# SERVICE BULLETIN

## SPECIAL INSPECTION TO INCREASE THE TBO FOR ROTAX® ENGINE TYPE 912 (SERIES) SB-912-005UL

Special inspection to increase the TBO for ROTAX® Engine Type 912 (Series).

**Fig. 1**  
**Friction washer**

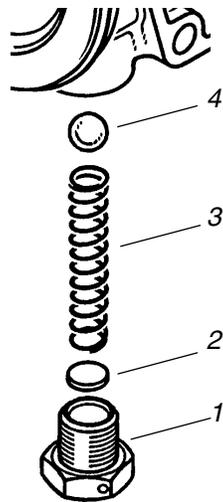
If hex. nut is still secured by a lock washer, it has to be exchanged for the friction washer (1) according to current Maintenance Manual (Heavy Maintenance).

**Fig. 2**  
**Improved oil pressure control**

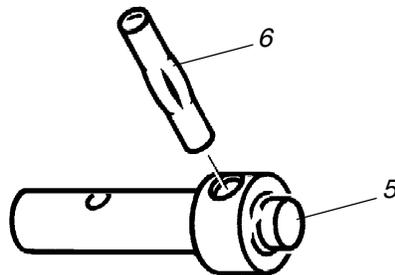
From engine S/N 4,005.186 onwards, to improve oil pressure control the following parameters of the relief valve were changed. Free length of the compression spring (3) was reduced from 46 mm (1.81 in.) to 39 mm (1.55 in.). Spring rate was changed by increase of wire dia. from 0,8 mm (.031 in.) to 0,9 mm (.035 in.), and dia. of ball was increased from 8 mm (.31 in.) to 8,5 mm (.33 in.). If existing, remove shim (4), but if specified oil pressure can't be reached, adjust pressure by adding shim again.

**Fig. 3**  
**Oil pump shaft**

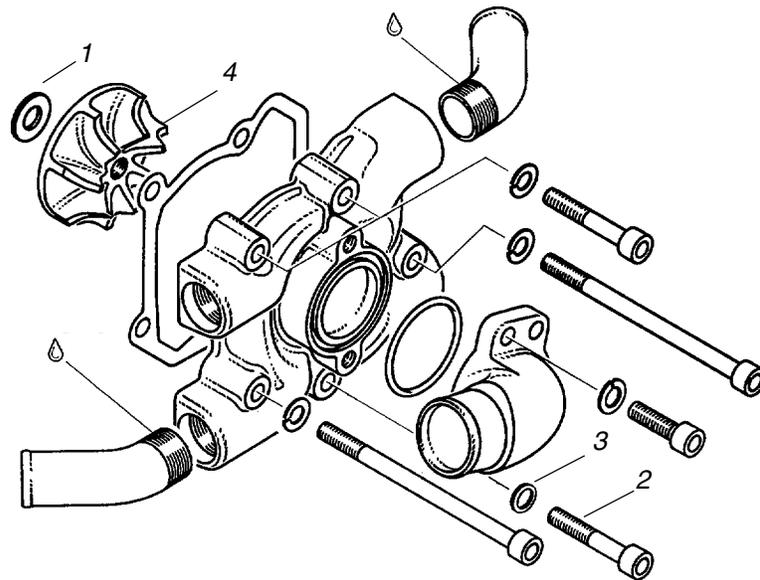
From engine S/N 4,152.101 onward the follower in the oil pump shaft (6) was changed to notched pin (5) instead of the former dowel tube.

**Fig. 5**  
**Check of float chamber**

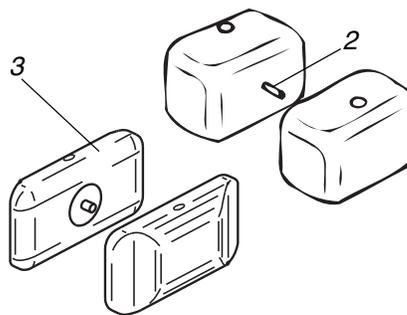
Remove float chamber and lift out both floats. If float chamber is still without distance pieces (1), part no. 861920, add them now, thus avoiding possible sticking of the floats in the float chamber.
